CERTIFICATE OF APPROPRIATENESS

**RE: Application Number 21-7194; 1627 (1627-1639) LEVERETTE; Corktown
Historic District**

Project:
Leverette Apartments - Exterior Corrections
Existing Apartment Renovations
Leverette Development, LLC
1627 Leverette Street
Detroit, Michigan 48216

SHEET TITLE
Rear Door and Wall Pictures

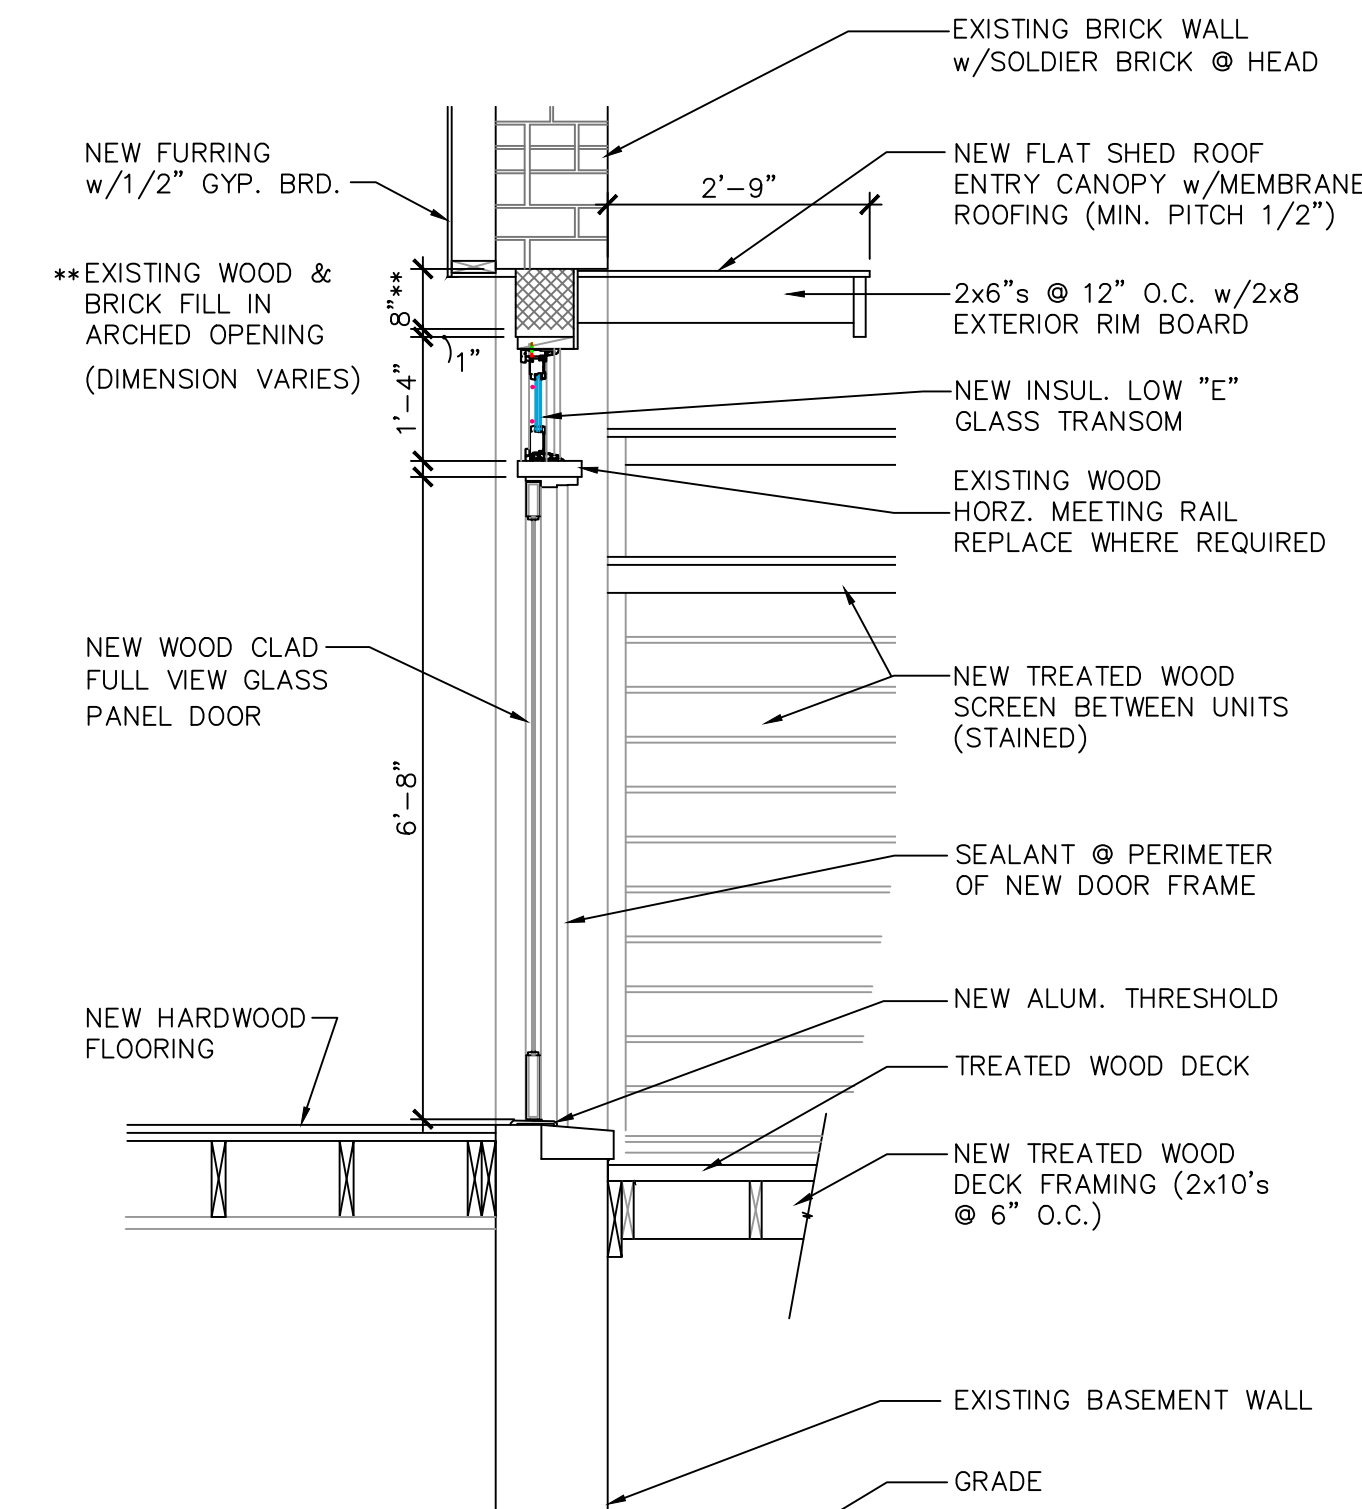
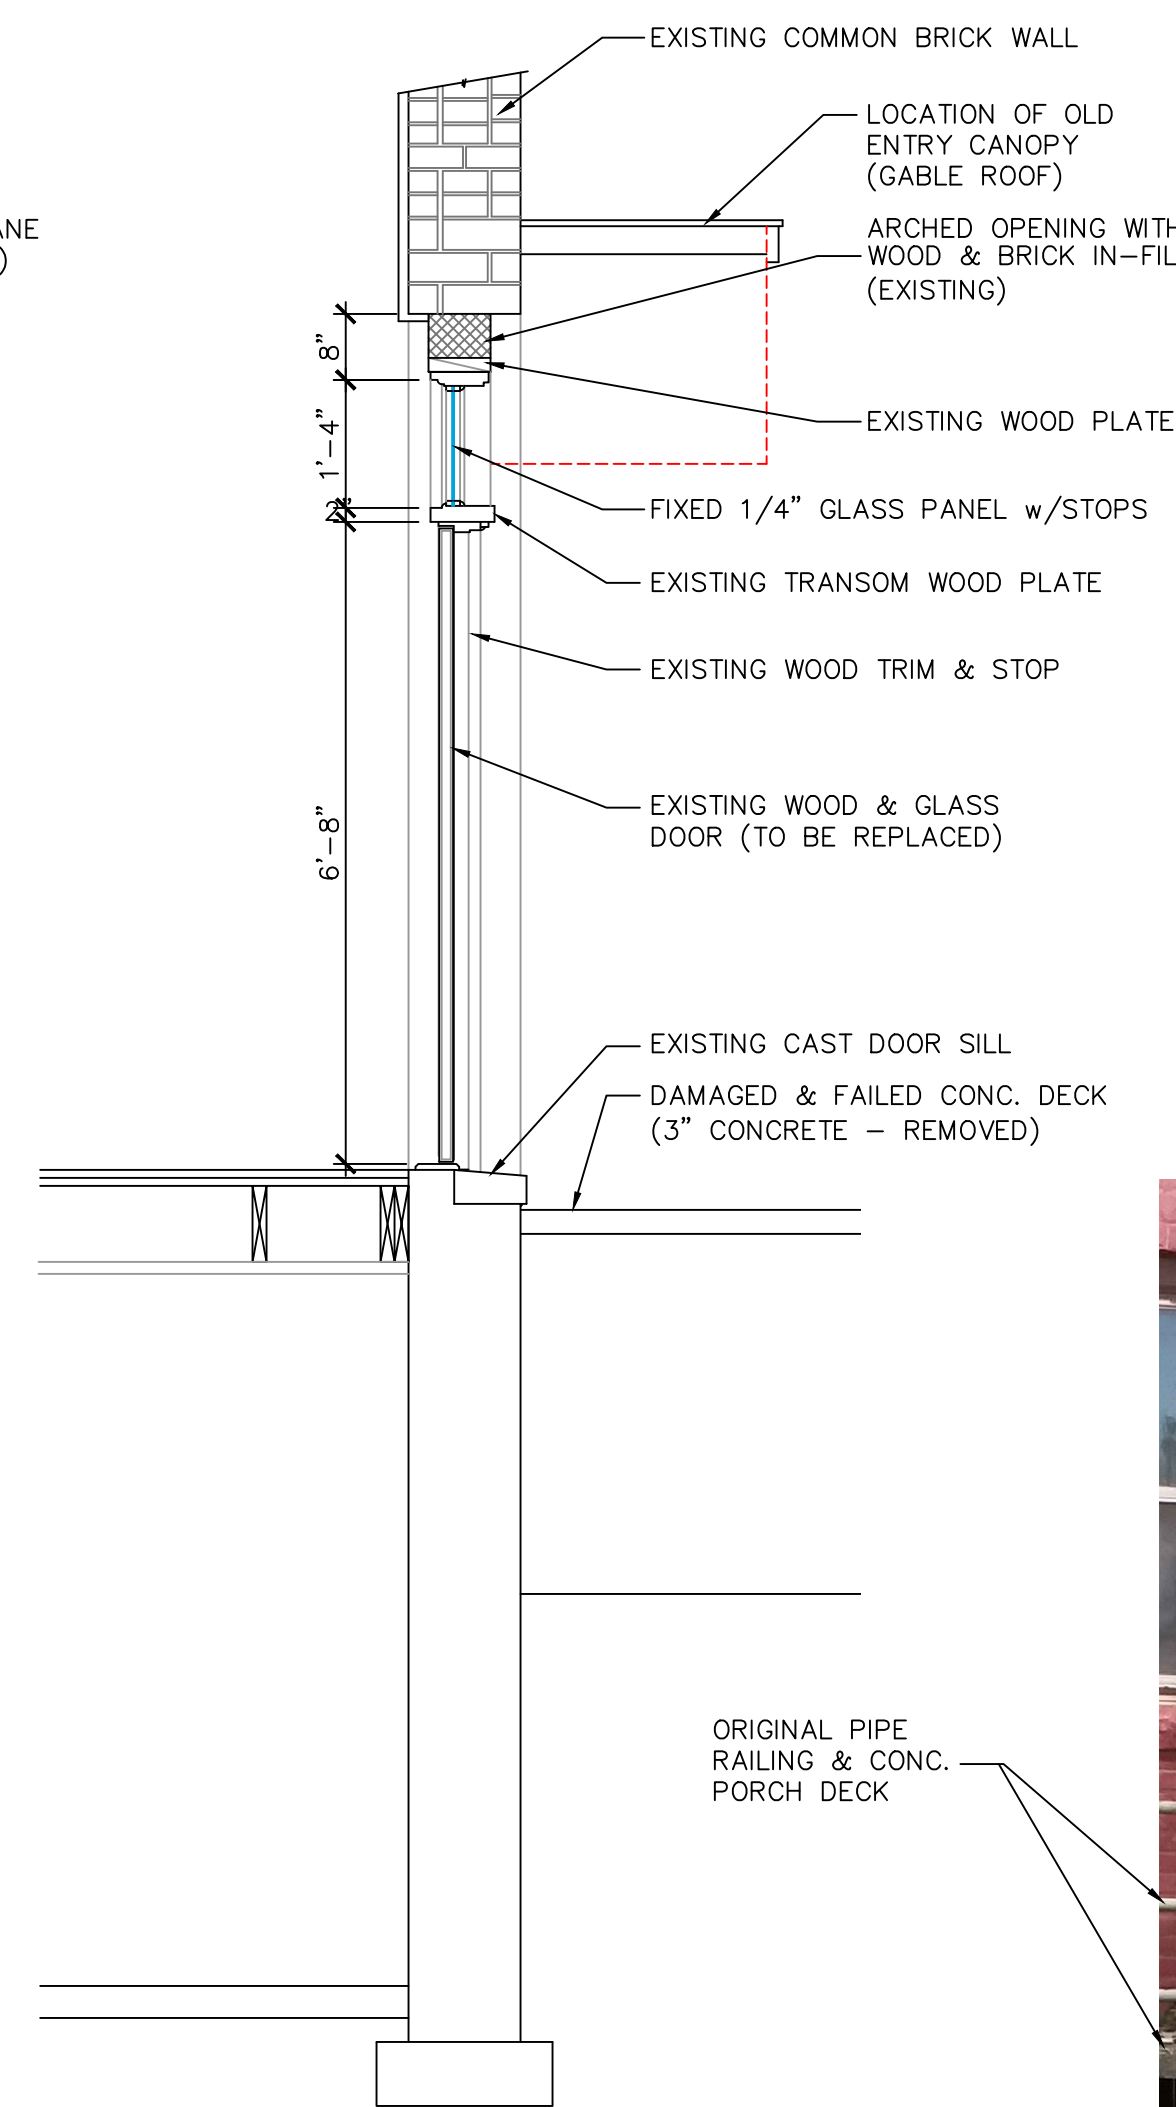
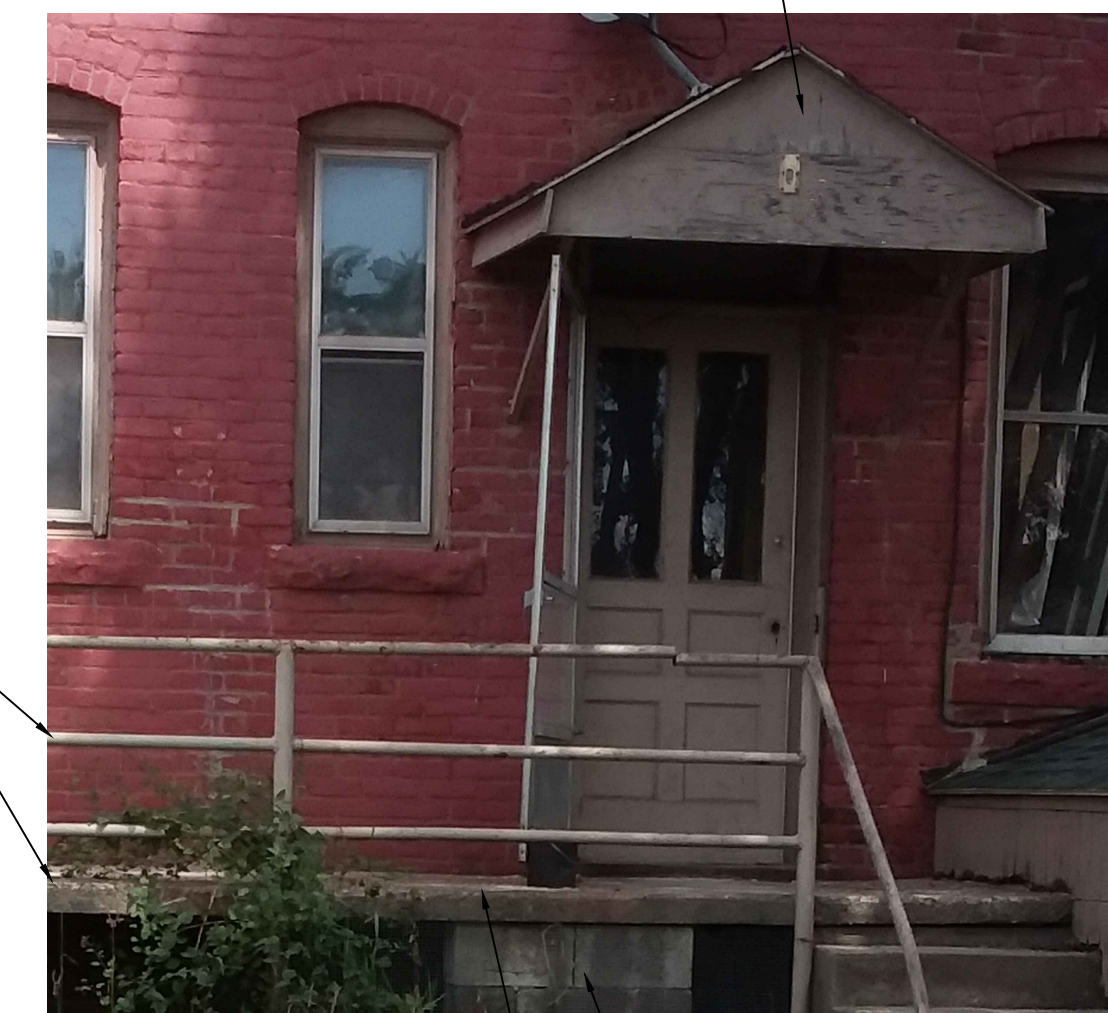
- At rear elevation, at each unit, remove the wood transom and trim from doorway and replace with new aluminum-clad wood unit (**work completed**). The new transom is shorter than the original. The open area above each transom shall be infilled with plywood to which a flat, metal overhang will be affixed.

- Each of the new transoms proposed for installation/installed at the rear elevation doorways shall be removed and replaced with a new aluminum-clad wood transom with a vision panel that better replicates the dimension/size of the original transoms.

SHEET TITLE
Car Port Plan and Elevation

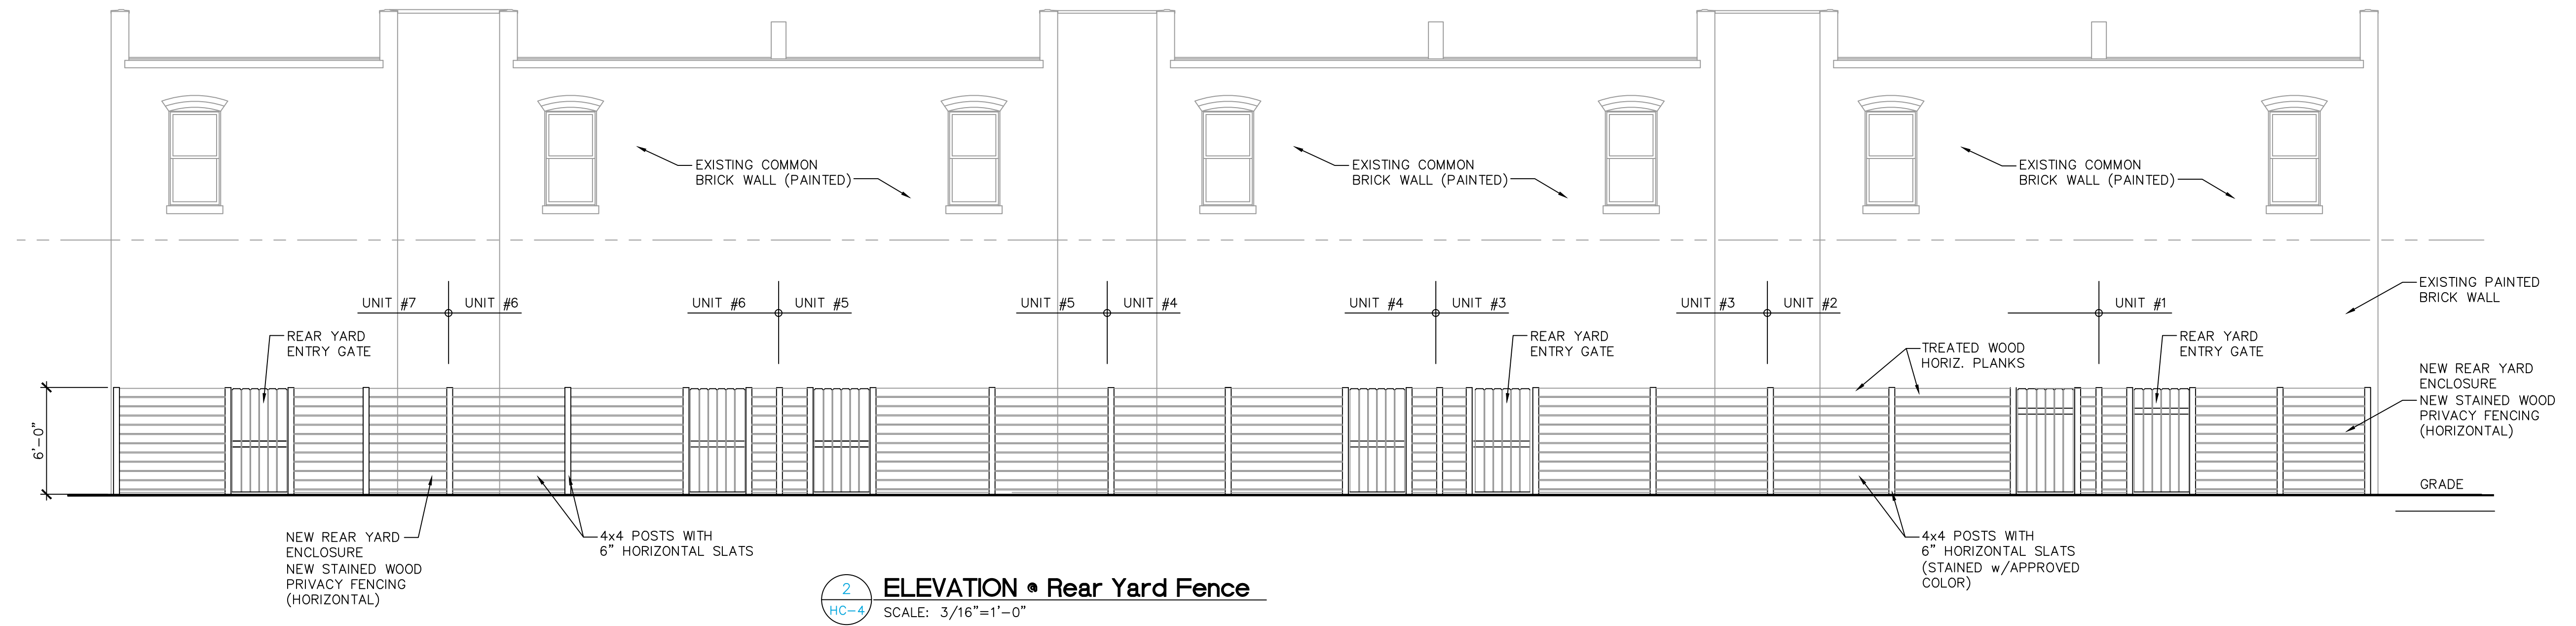
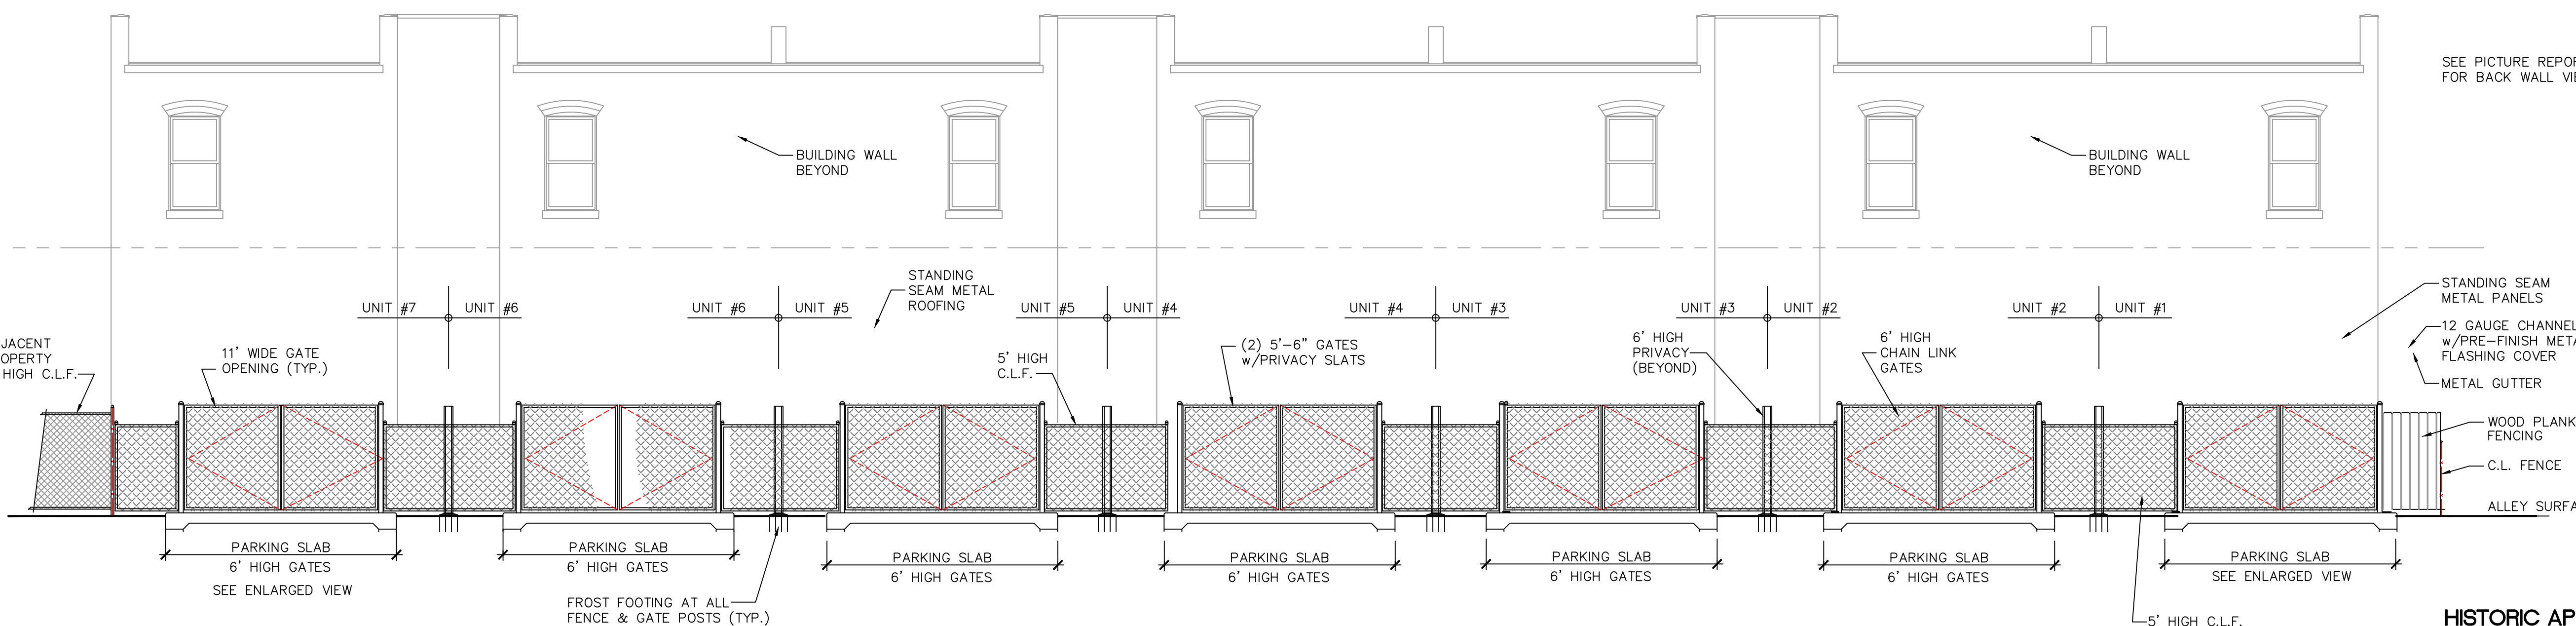
The originally approved rear yard fencing was 4' high chain link fencing. We are proposing to install a new 6' High - Treated Wood (Stained) Privacy Fence along each unit's separation line. (See site drawing for location).

- The newly-erected fencing, gates, rear yard walls, and rear porches cannot be unfinished. Rather, they must be stained or painted a color which complements the building. The owner or applicant shall submit a proposal to HDC staff outlining the color palette for the garages’ wood elements for review and approval prior to staff’s approval/signoff of the project’s final construction drawings. Also, these elements must be painted or stained as per the approved color scheme on or before April 14, 2022.
